IEEE 802.3cb PCS compatibility to 1000BASE-X PCS

2017-10-19

Yong Kim

2.5x-GMII TX → XGMII RX, Issue – Lane 3 SFD

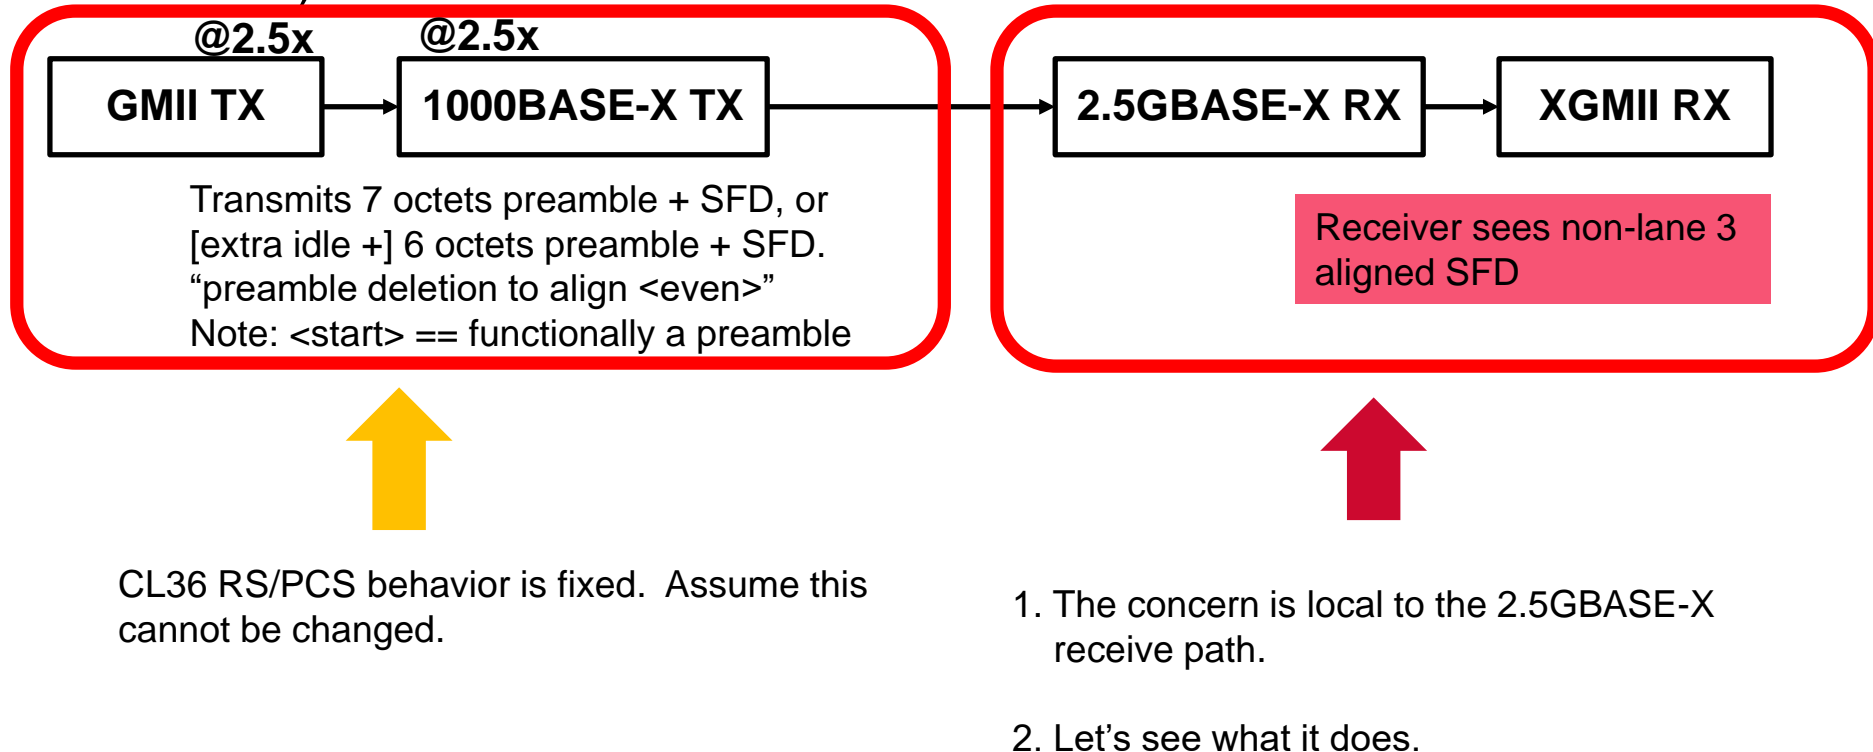
- CL46 XGMII lane 0 <start> and lane 3 SFD compatibility, when CL36 PCS sends extra idle bytes that replaces preamble (“odd-even alignment function”).

Figure 127–2—Functional block diagram

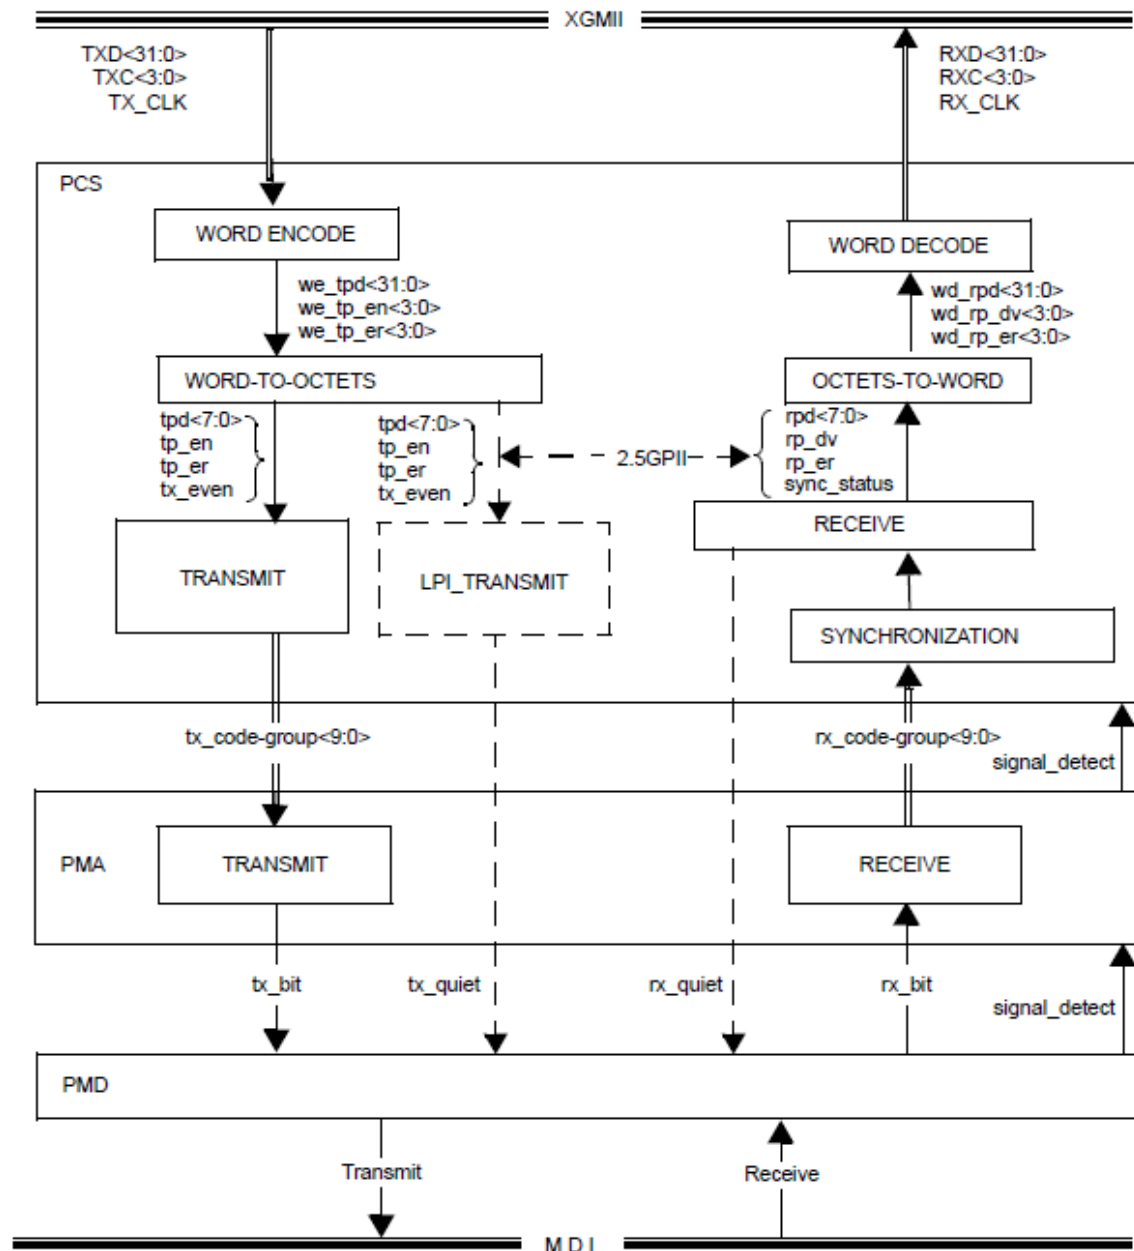
- **Comment:** As stated in annex 127A 'It is permissible for a compliant 1000BASE-X PCS transmit process to truncate the first byte of a preamble in order to align the start of packet on the EVEN boundary.'. In the 2.5GBASE-X receive path the WALIGN function called by the RX_XGMII state of the Figure 127-9 'Octets-to-Word and Decode state diagram' performs alignment according to subclause 127.2.4.4. Based on the rules described in that subclause the first packet received will set the Deficit Idle Count to place the first Data symbol, in this case the SPD replaced by a preamble octet by the PCS, on wd_rpd<7:0> of the 2.5GPll. This in turn will be encoded as a XGMII 'start' (RXC = 1, RXD = 0xFB) on lane 0 as required by Clause 46. As noted above the first octet of preamble may be discarded on transmit by a 1000BASE-X PCS. This results in the transmission of, and therefore reception of, a 7 octet preamble. With the first octet of this 7 octet preamble aligned by the WALIGN function on XGMII lane 0, the SFD will be received on Lane 2 of XGMII, not Lane 3 as illustrated in IEEE Std 802.3-2015 Figure 46-8 and 46-9. IEEE Std 802.3-2015 subclause 46.3.3.3 'Response to received invalid frame sequences' states 'Error free 10 Gb/s operation will not change the SFD alignment in lane 3' and 'A 10 Gb/s MAC/RS implementation is not required to process a packet that has an SFD in a position other than lane 3 of the column following the column containing the Start control character.' There appears to be no changes to this text as a result of IEEE Std 802.3bz-2016 amending the XGMII specification to support operation at 2.5 Gb/s and 5 Gb/s as well as 10 Gb/s. As a result the above text only applies to XGMII 10 Gb/s operation and IEEE 802.3 is silent in this respect for 2.5 Gb/s and 5 Gb/s XGMII operation. That being said, there may be an assumption made that a 10 Gb/s MAC/RS/XGMII implementation may also support 2.5 Gb/s operation through quarter rate clocking. This however is not the case if the implementation took the option of not processing packets that have an SFD in a position other than lane 3 as is permitted by IEEE Std 802.3-2015 subclause 46.3.3.3. **If that option is implemented** all packets received from a 2.5GBASE-X would not be processed as the SFD will always be received in lane 2.

- **Suggested Remedy:** While strictly speaking IEEE Std 802.3-2015 subclause 46.3.3.3 only applies to a 10 Gb/s MAC/RS/XGMII, to avoid any incorrect assumptions, suggest that:
[1] The text '...to be able to accept a seven byte preamble on the XGMII.' in the penultimate paragraph of Annex 127A be changed to read '...to be able to accept a seven byte preamble on the XGMII with the SFD positioned on lane 2.'
[2] A note that reads 'Note: To support 2.5GBASE-X compatibility with a 1000BASE-X PCS/PMA running 2.5 times faster, a 2.5Gb/s MAC/RS implementation has to support a Start control character received on either lane 2 or lane 3.' Be added to the end of subclause 46.3.3.3
